TECHNICAL SERVICE BULLETIN

TSB#: 13-002 Job Code: 99801153 Flat Rate: 0.25 HRS

ACTION REQUIRED: Replace the struts on both sides of the Murphy bed

2013 Jay Feather Ultra Lite Travel Trailers

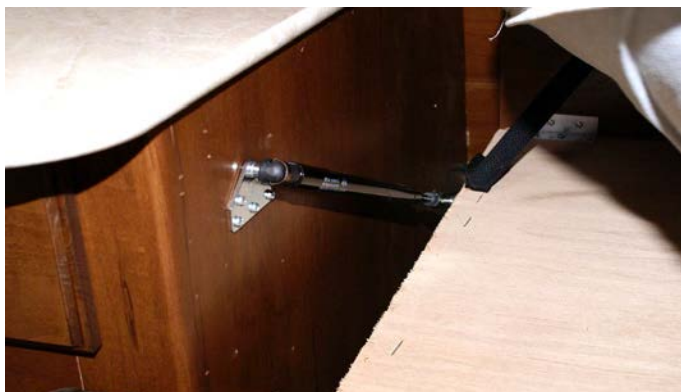
- 13-002
- (2) Struts
- (1) Caution label
- Instruction sheet

1. Open the sofa into the bed position. Open the Murphy bed.
2. Using a clean rag and soapy water, clean a small area in the center of the rear wall. Allow the area to thoroughly dry.
3. Apply the caution label to the back wall.
4. Move the mattress to the side away from the strut.
5. Using the flat head screwdriver, carefully pry the strut out of the top bracket. Remove the strut from the bottom bracket.
NOTE: It is not necessary to remove any of the strut brackets.
6. Insert the replacement strut in the bottom bracket. Apply enough pressure to the strut so it clears the top bracket. Insert the top of the strut in the top bracket.
7. Repeat Steps 4-6 on the other side.
